SUBJECT: Forwards responses to NRC 830127 letter const of revetment ditch sys at facility. One oversize figure encl. Aperture card is available in PDR.

Re: Nine Mile Point Unit 2  
Docket No. 50-410

In a letter dated January 27, 1983 from Mr. Schwencer to G. Rhode, two questions were provided regarding the construction of the revetment ditch system at Nine Mile Point Unit 2. The questions and responses are enclosed.

POWER INDUSTRY GROUP		TITLE		SCALE:	
CHECKED		Granular Filter		DATE:	
CORRECT		Gradation Requirements			
APPROVED					
REVISIONS	(2)	(3)	(4)	(5)	Figure 2

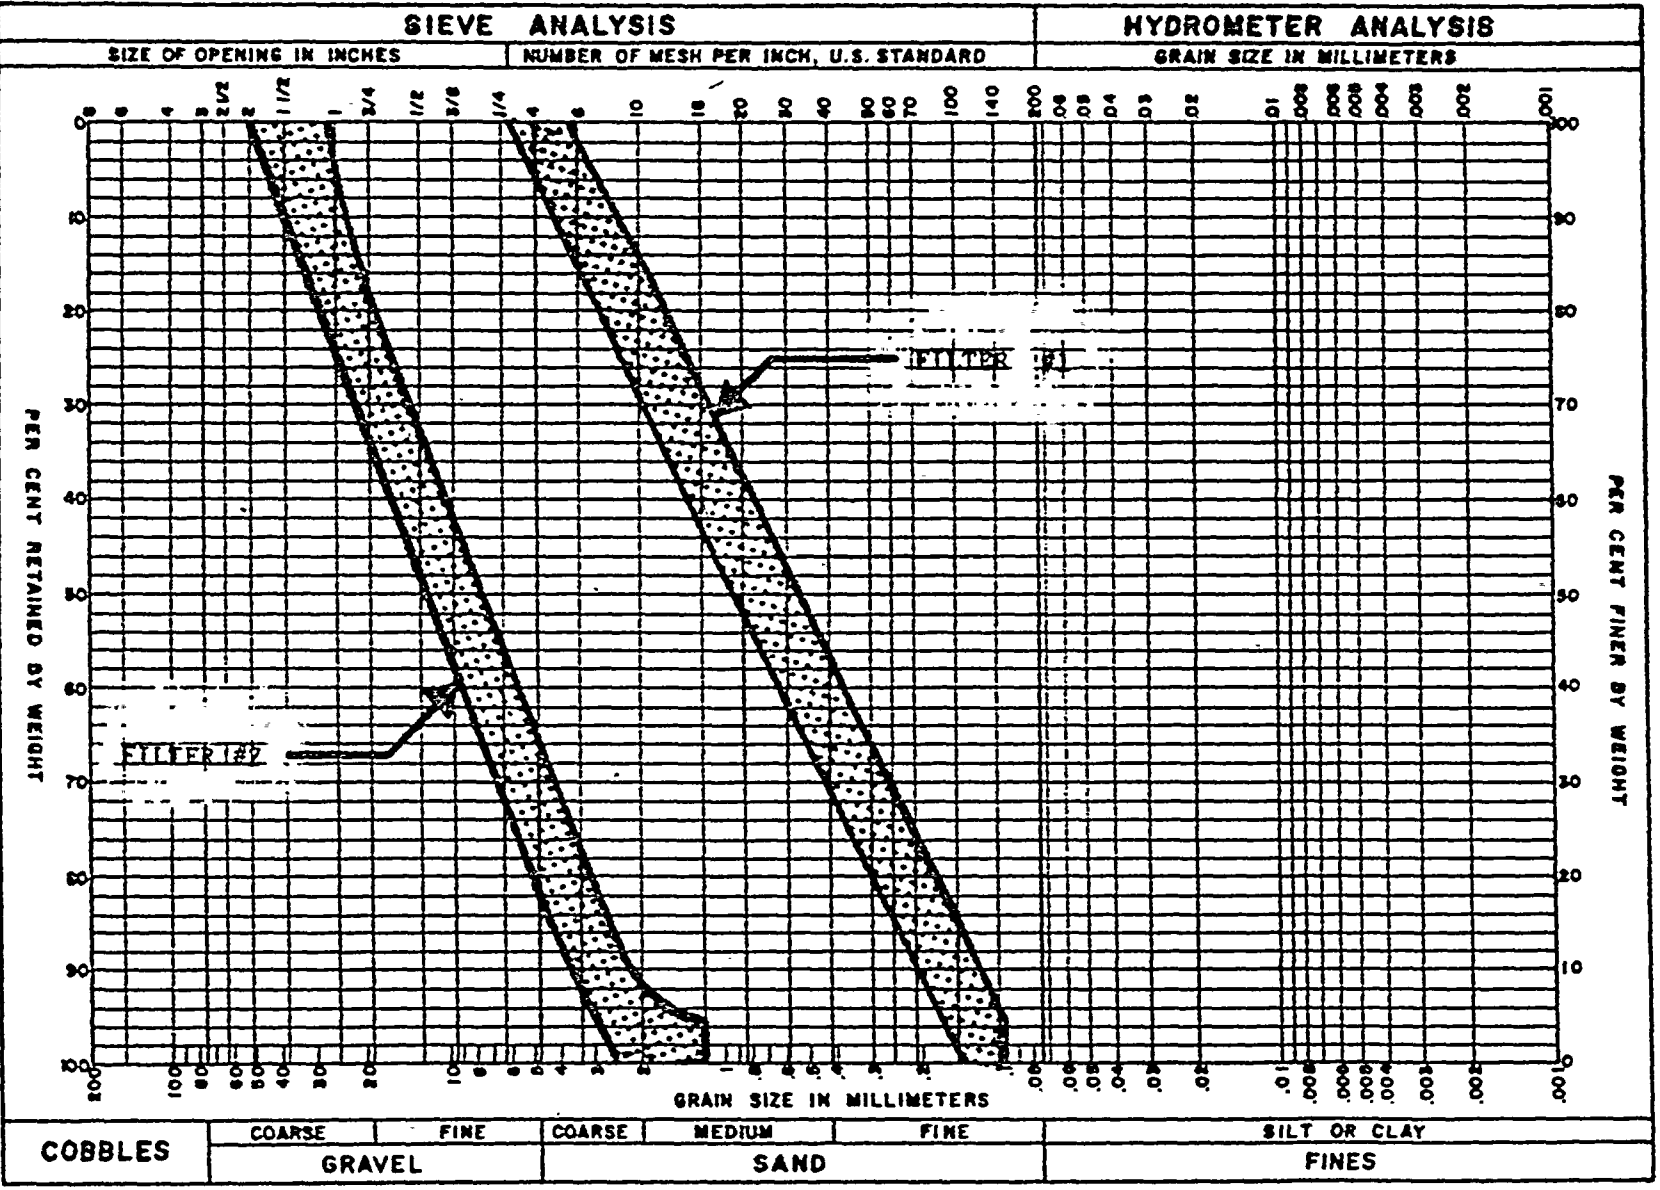
- A. Gradation specifications thickness and slopes of the various quarry stones under and filter layers comprising the revetment ditch system.
- B. Gradation of the insitu soil.
- C. Type, weight and dimension of the primary concrete armor units, as well as the basis for, and details of, the revetment reinforcement for the armor units.

- A. The gradation thicknesses and slopes of the quarry stone layers in the revetment ditch system are shown in Figure 1. The gradation requirements of the two zone granular filter medium are illustrated in Figure 2.
- B. A typical gradation curve of the insitu soil for which the granular filter medium were designed is shown on figure 3.
- C. Details regarding type, weight and dimensions of the 4900 pound dolosse are shown in Figures 4 and 5. Each dolos unit contains approximately 4% of epoxy coated reinforcing steel by weight. The reinforcing steel arrangement is shown on Figure 6. The basis for reinforcement of the armor units is to obtain the desired weight and maintain the integrity of the units.

FIGURE 1  
REVETMENT DITCH  
PLAN AND TYPICAL SECTIONS  
NIAGARA MOHAWK POWER CORPORATION  
NINE MILE POINT-UNIT 2

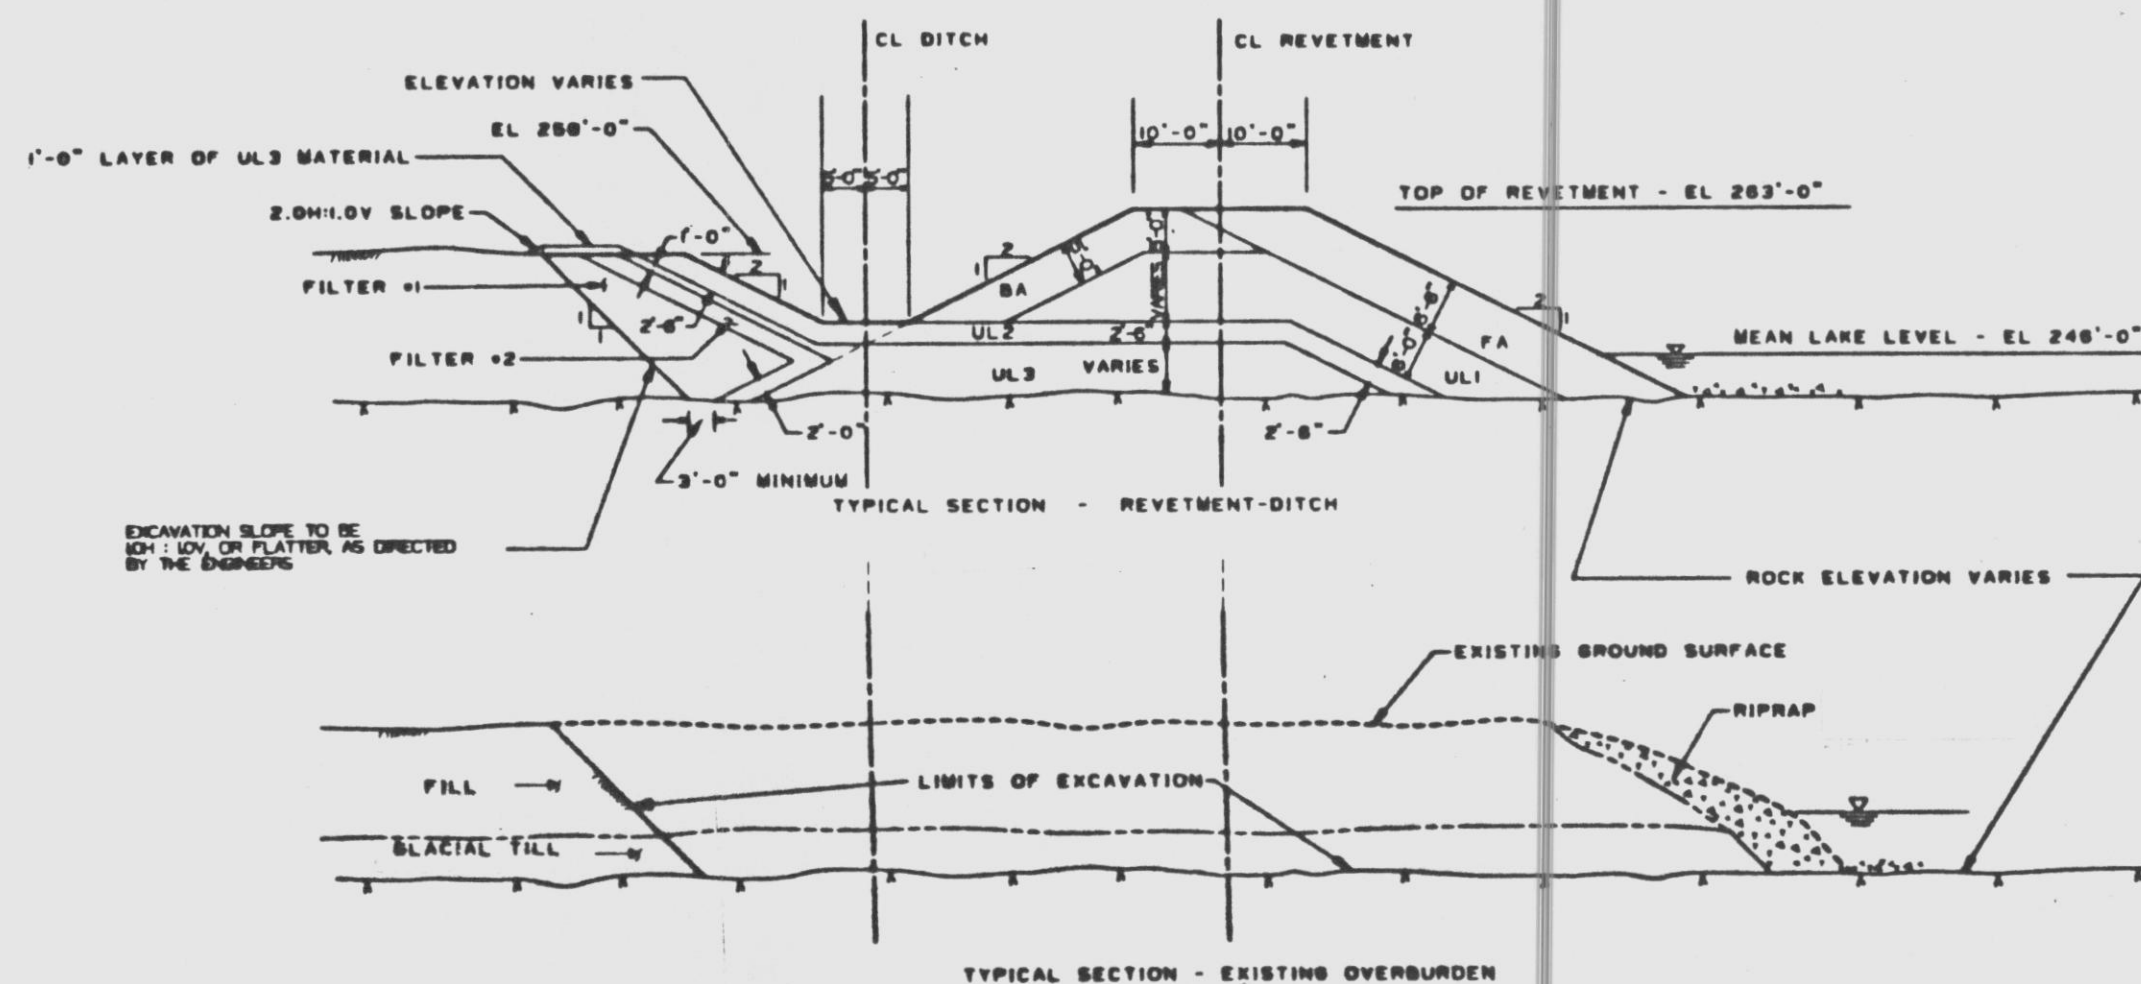
As certain items cited in references 2 and 3 are no longer applicable to the final revetment ditch design, provide a detailed drawing of the revetment ditch system which indicates the following details:

As shown on Figure 1, all existing materials (insitu) below the slopes of the ditch shall be excavated and replaced with quarry stone materials. Therefore, no stability analysis on a natural soil zone below the ditch was performed.
